ADDENDUM NO. 2

TO THE DRAWINGS AND SPECIFICATIONS
FOR THE
Harrison Elementary School-Preschool Addition & HVAC Upgrade
Lexington, Kentucky
RTA 2251
BG 23-124
FCPS Bid 56 -23
November 9, 2023

Date: 11/08/2023
Project: Harrison Elementary School Renovations

Addendum Number: 2

450 PARK PLACE, LEXINGTON, KY 40511
FOR
HARRISON ELEMENTARY SCHOOL - PRESCHOOL ADDITION
SITE DETAILS

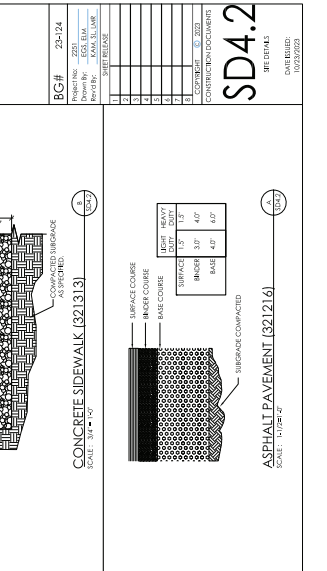
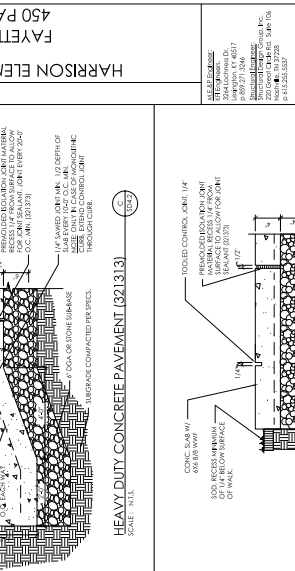
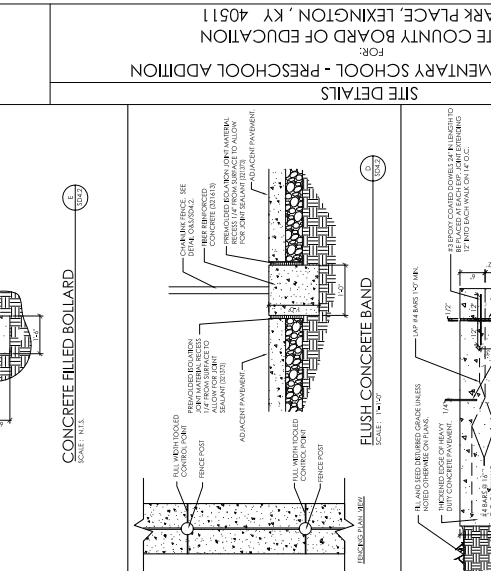
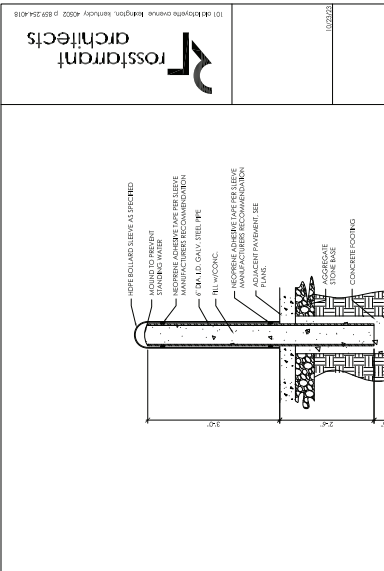
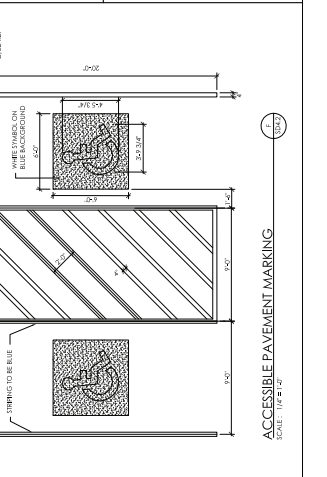
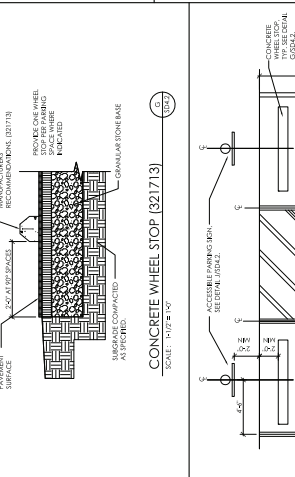
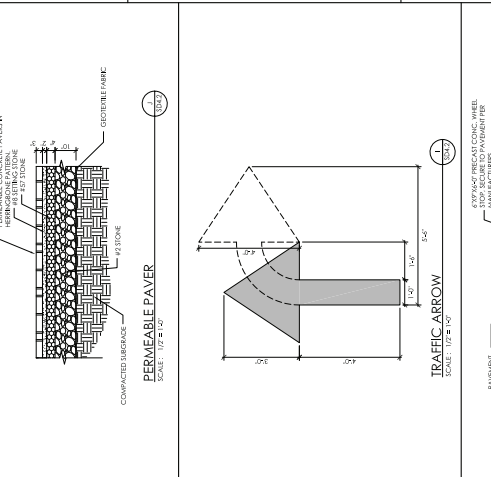
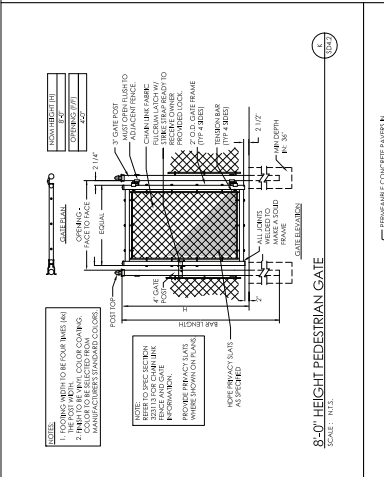
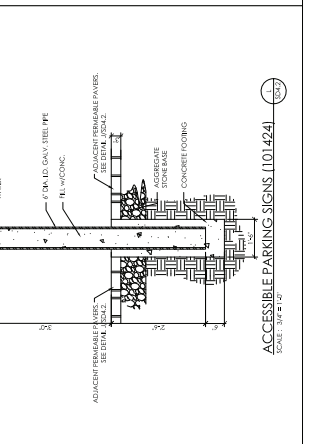
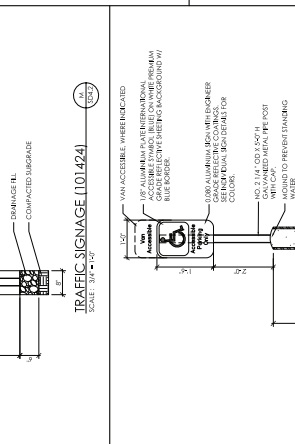
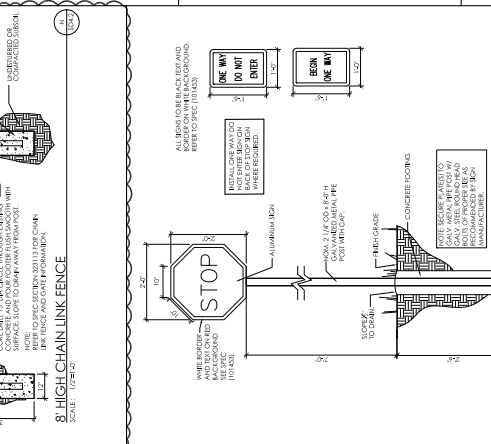
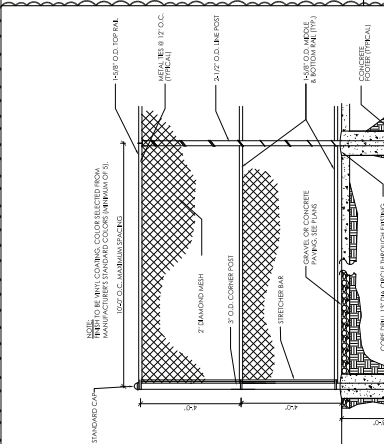
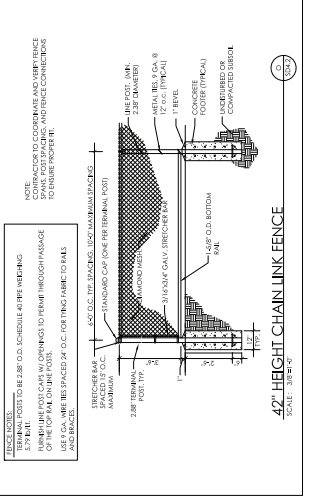
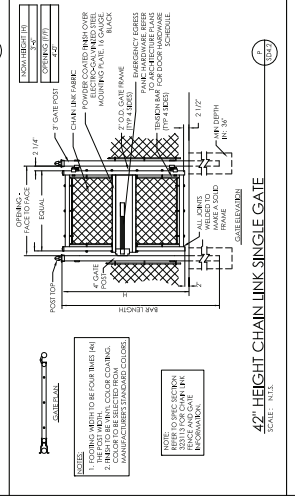
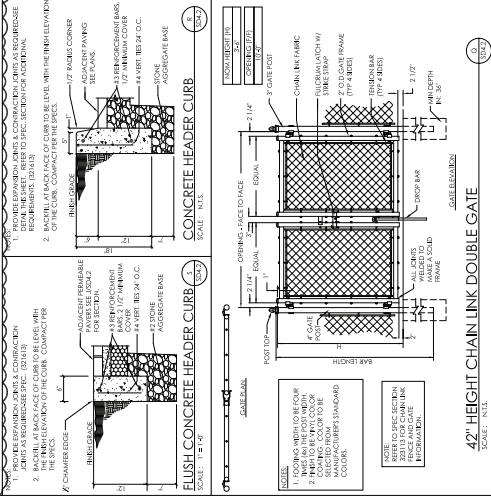
- a) Remove detail T/SD4.2.
 - b) Revise detail N/SD4.2 to be 8’ Height Chain-link Fence as shown on **attached sheet SD4.2**
- 7. **Refer to Sheet SD4.3:**

- a) Detail D. Update note regarding handrail to read “1 ½” Outer Dia. Galvanized Steel Pipe.”
- 8. **Refer to Sheet SD4.4:**
 - a) Remove note on detail A/SD4.4 about owner-provided windscreen as shown on **attached sheet SD4.4**
